Georgia Department of Natural Resources

October 10, 2008

ATTACHMENT A
Supplemental Information
Letter from Carol Couch to Colonel Byron Jorns
October 10, 2008

Figure 3
Dissolved Oxygen at Capps Ferry Bridge
2007 Chattanooga River Model Predicted versus 2008 Actual

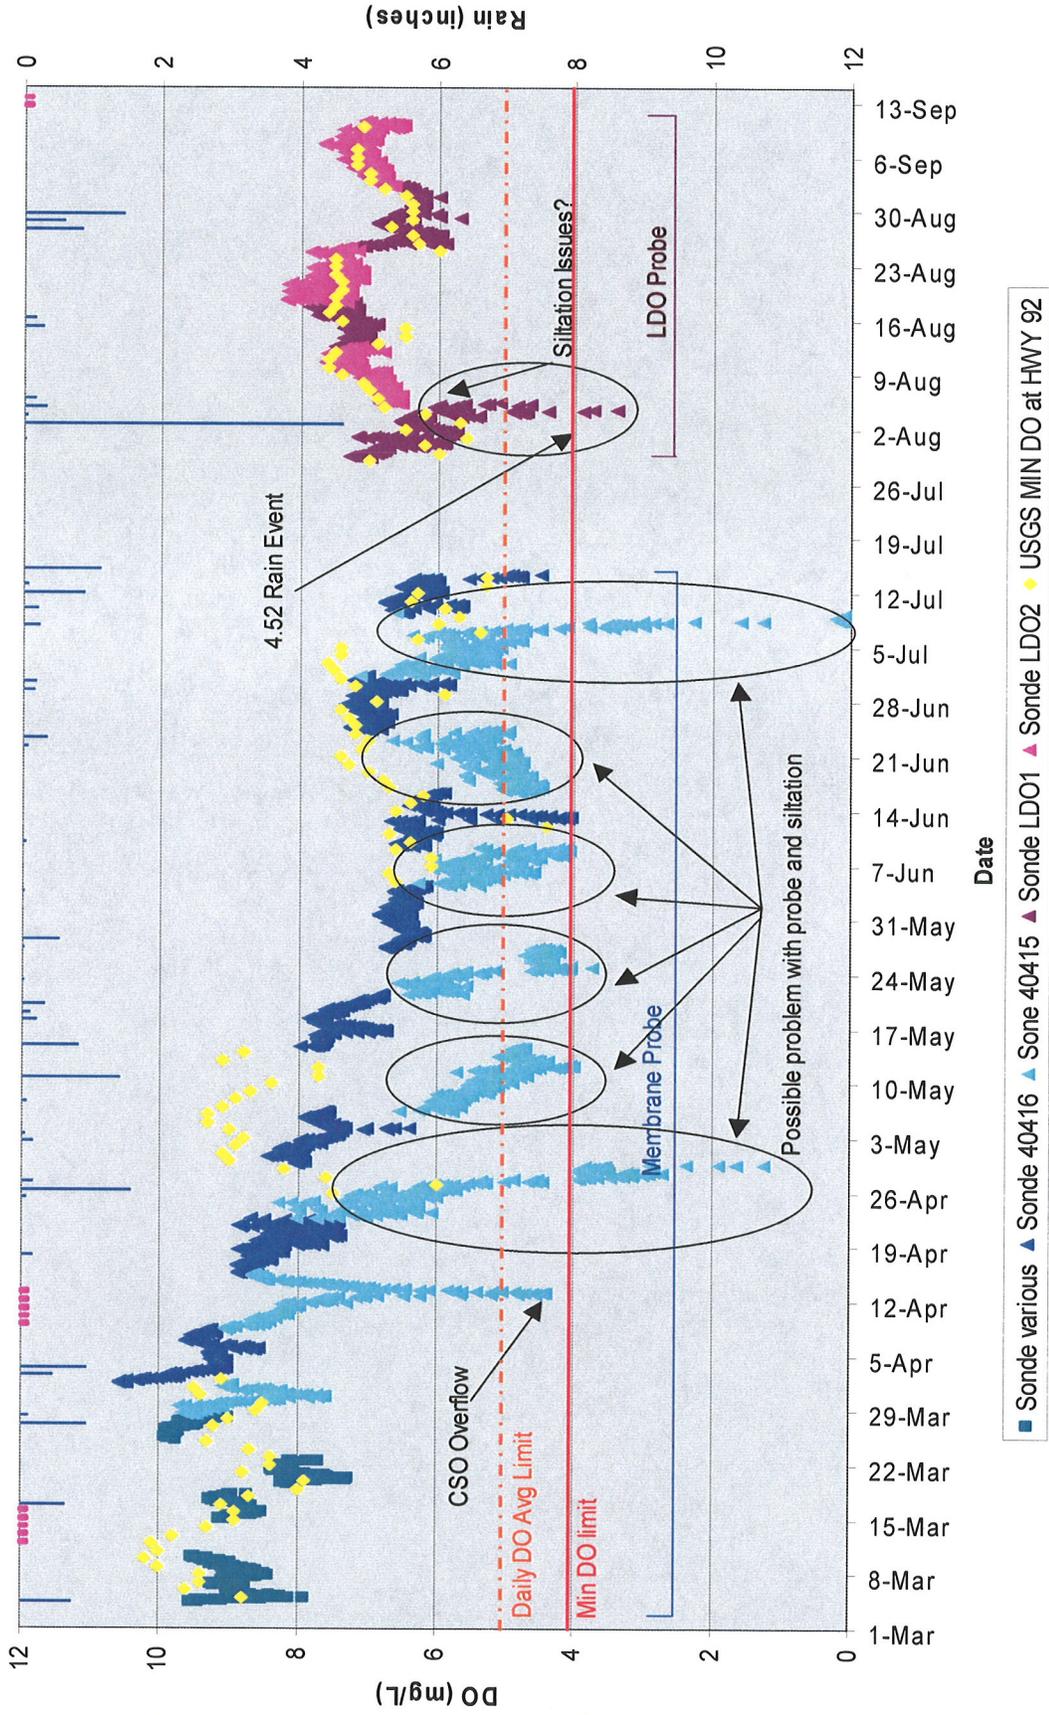
The DO data collected at Capps Ferry and the Fairburn gage generally validate the model results. Figures 3 compares the results of the 2008 DO monitoring at Capps Ferry to the 2007 EPDRIV1 model predictions, excluding unusable data as discussed above. Figure 4 presents the 2007 daily average DO monitoring data from the USGS Fairburn gage and instantaneous readings collected by EPD at the Fairburn gage plotted against the results of the 2007 EPDRIV 1 model predictions at the same location. As shown there is generally good correlation between the actual data and the model at both locations thus validating the model.

Figure 5
Predicted Chattahoochee River Ammonia Concentration Profile
for Minimum Streamflow of 650 cfs at Peachtree Creek

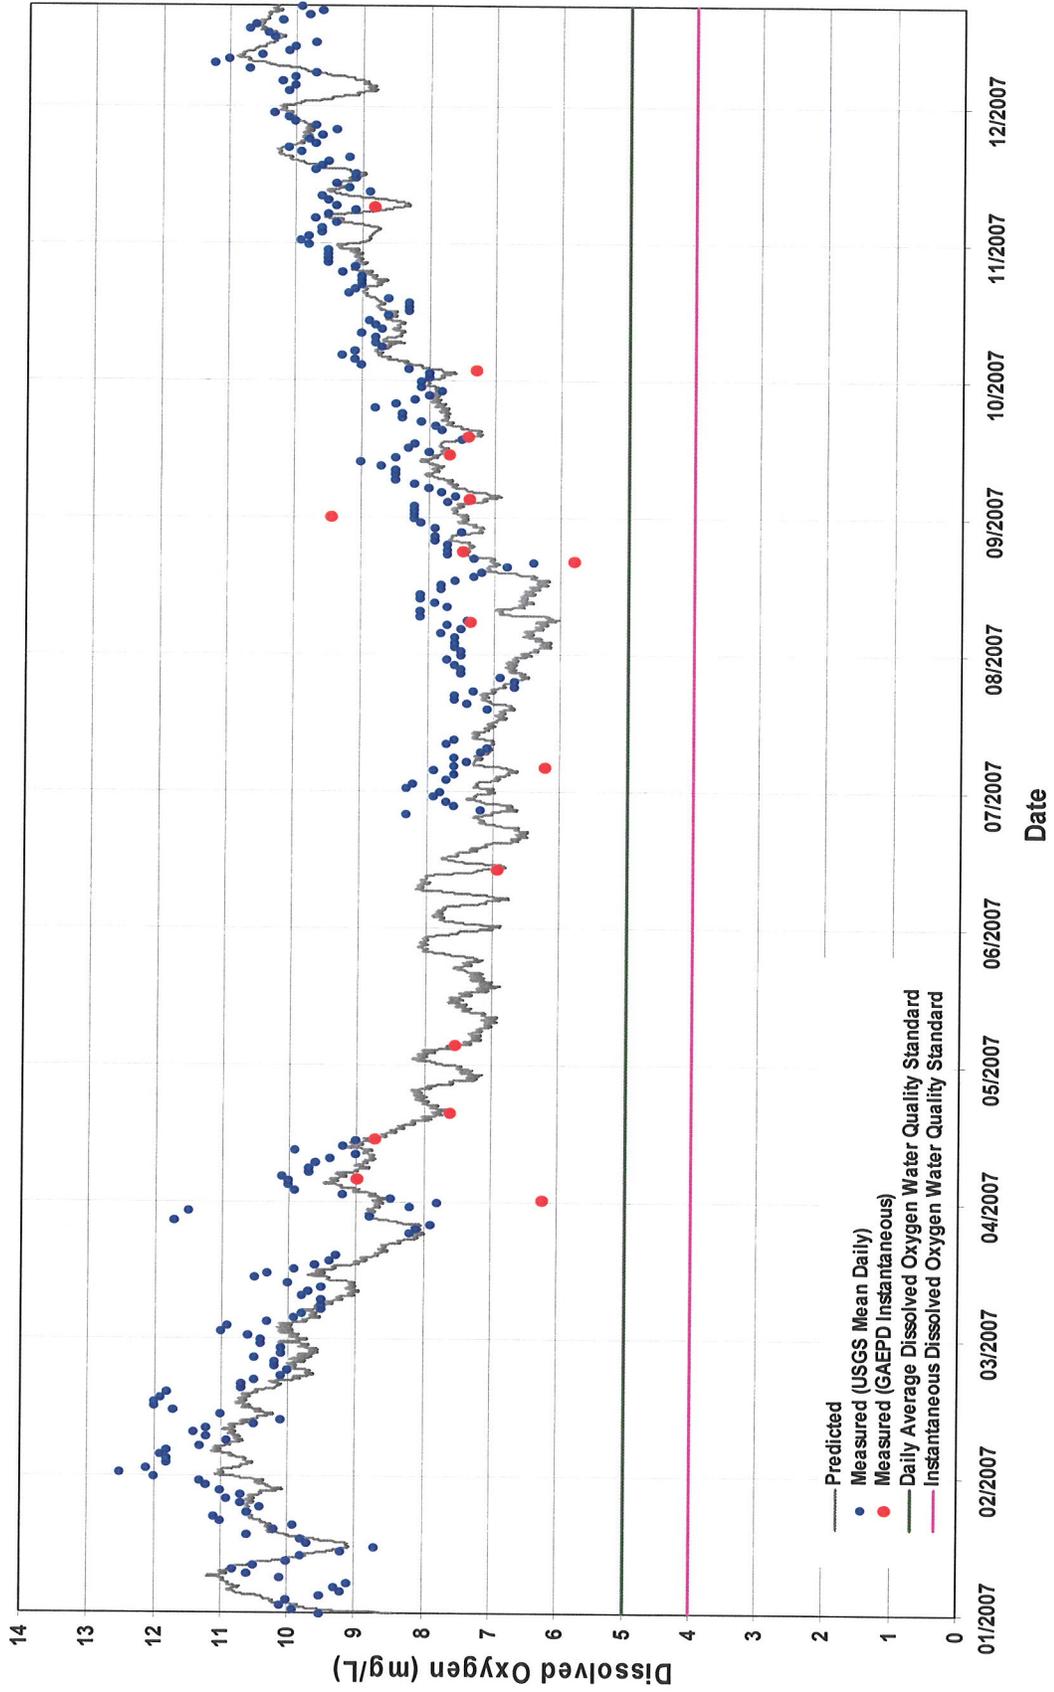
Ammonia Toxicity - In addition to DO, the updated model results also show that the predicted in-stream ammonia concentrations will be far below maximum allowable concentrations. As shown in Figure 5, the model predicts that ammonia concentrations will peak approximately ten miles downstream of Peachtree Creek at the Interstate 20 crossing of the Chattahoochee River. Predicted

Figure 6
Predicted Chattahoochee River Maximum Ammonia Concentrations
for Minimum Streamflow of 650 cfs at Peachtree Creek
(Concentrations are at maximum location.)

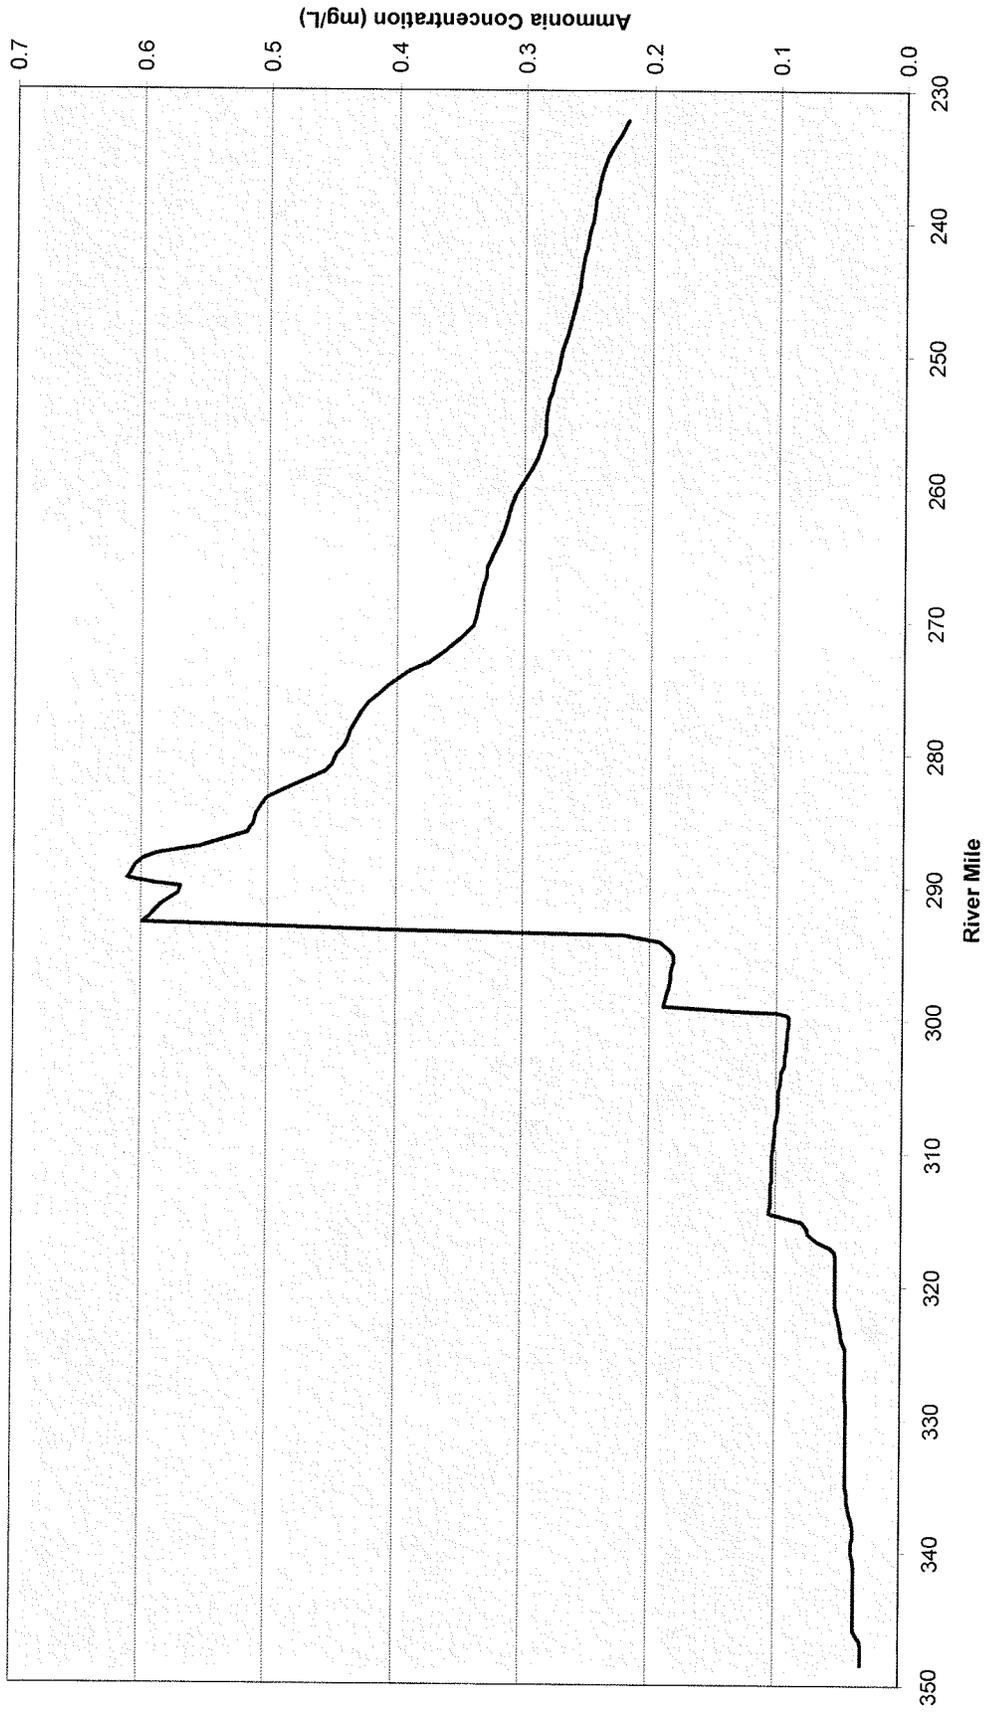
ammonia concentrations at this location are shown in Figure 6 and, in Figure 7, the predicted concentrations are compared to the maximum allowable ammonia concentrations. There is no single number in-stream standard for ammonia; instead the maximum in-stream concentration of ammonia allowed depends upon the temperature and pH of the receiving stream. Figure 7 shows what the model predicts the maximum allowable ammonia concentration would be for selected pH. Variations in the maximum allowable concentration for each selected pH is attributable to in-stream temperature variations. As shown in Figure 7, ammonia concentrations will be substantially below allowable limits.
